STAFF REPORT

Re: <u>Veranda West — Site Plan Request</u>

Application No.:SPR-916-2019Applicant:Adam Lankford, representing Wasatch ResidentialProject Location:Approximately 13638 S. 600 WestCurrent Zoning:TSD (Transit Station Development) ZoneAcreage:Approximately 9.12 Acres (approximately 397,267 square
feet)Request:Request for approval of a Site Plan application in the TSD
zone for the construction of a 122 unit townhome
development.

EXHIBIT A DEPARTMENT REVIEWS

EXHIBIT E SITE PLAN

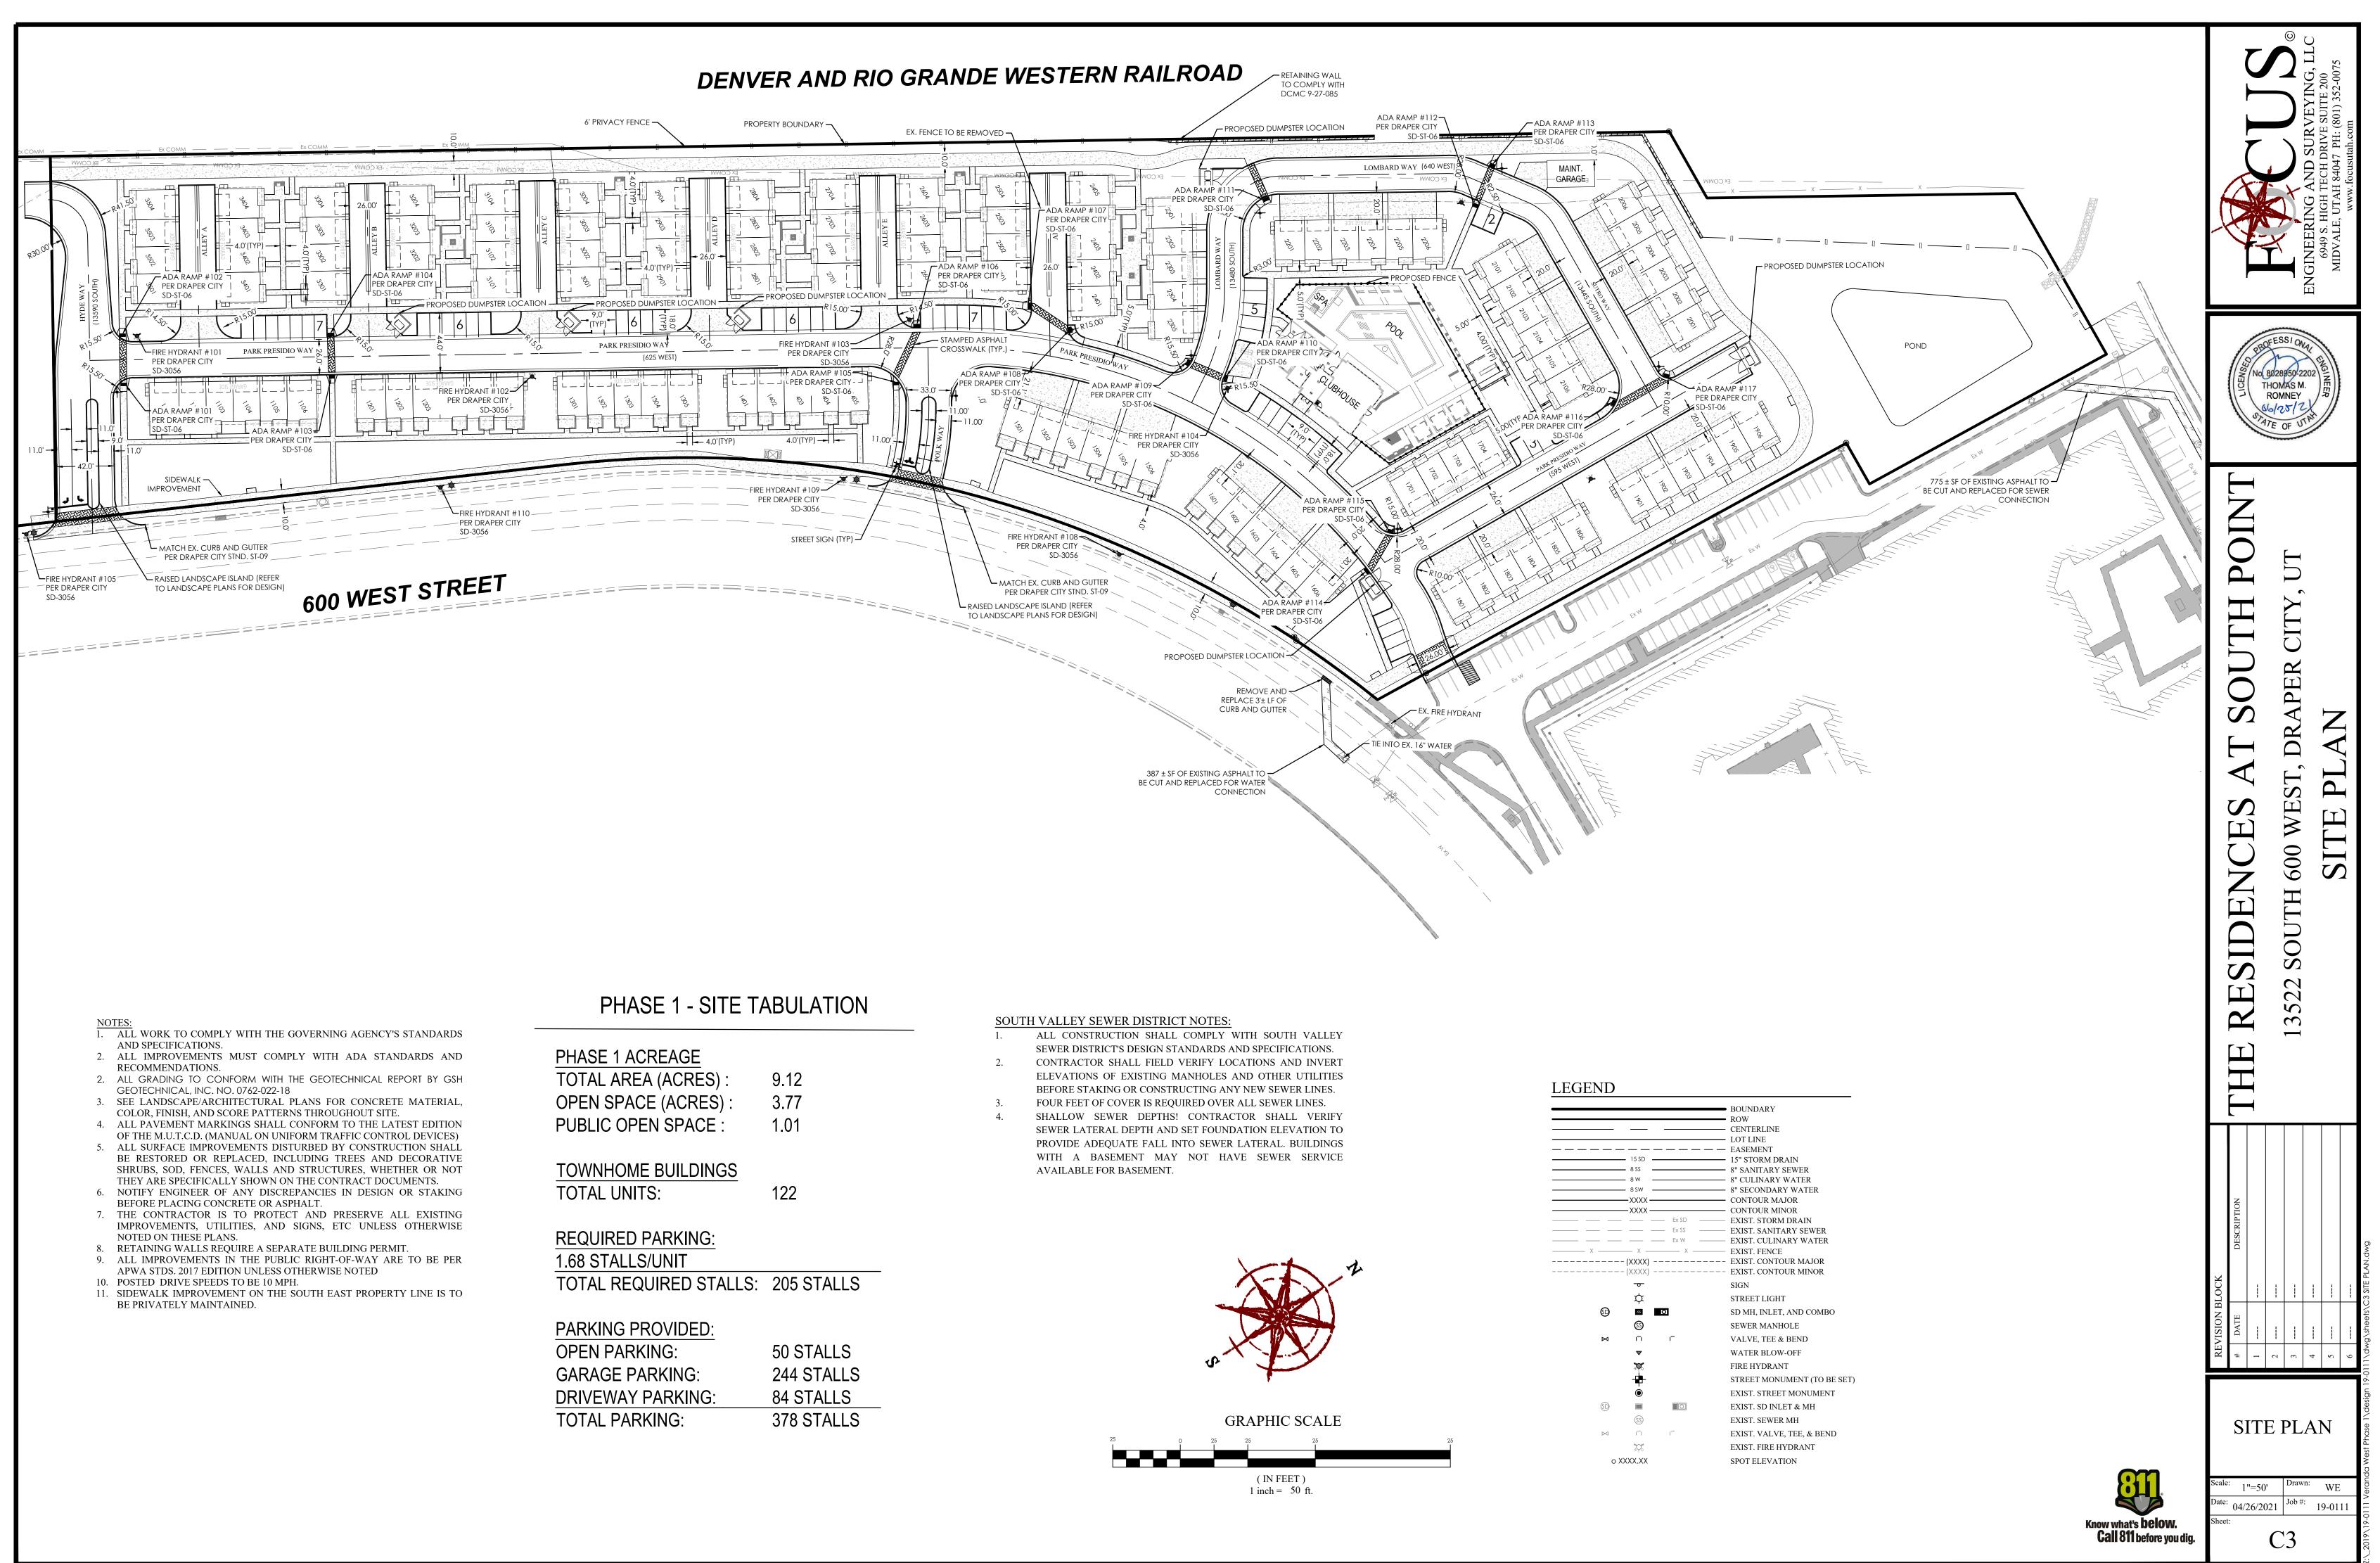
- 2. All subsurface drains or land drains require a private maintenance plan and protective covenants per DCMC 17-3-030(K) and 17-3-030(N). Plans do not make it clear if a subsurface system will be required.

- 5. Any work in the public right-of-way will require an Encroachment Permit obtained through the Engineering Division.
- 6. Provide cross lot access easement where access is required between adjacent sites. See DCMC 9-25-080(B) and (E).

- 7. We recommend no manhole access are located within sidewalks due to potential tripping hazard from the lids. *Response indicates that manhole lids will remain in the trail alignment. Informational comment. No additional response required.*

- 9. Garbage collection structures, for example at unit 210, appear to impact safety of vehicles entering and leaving alley by blocking sight distance and encroachment into the clear view areas. *Response indicated that an engineering review has been completed and determined that the sight distance and clear view are not an issue at each of these locations. Informational comment. No additional response required.*

10. Right turn lane (and center turn lane) required when a proposed private street connection is made to an existing arterial street. See DCMC 11-2-050. *TIS does not require a dedicated right-turn lane on the arterial street. The right-turn lane will be a shared lane with the outside southbound travel lane.*

- 1. Fire Department Access is required. An unobstructed minimum road width of 26' exclusive of the shoulders and a minimum height of 13'6" inches shall be required. The road must be designed and maintained to support the imposed loads of emergency apparatus. The surface shall be able to provide all weather driving capabilities. The road shall have an inside turning radius of 28' feet. There shall be a maximum grade of 10%. Grades may be checked prior to building permits being issued.
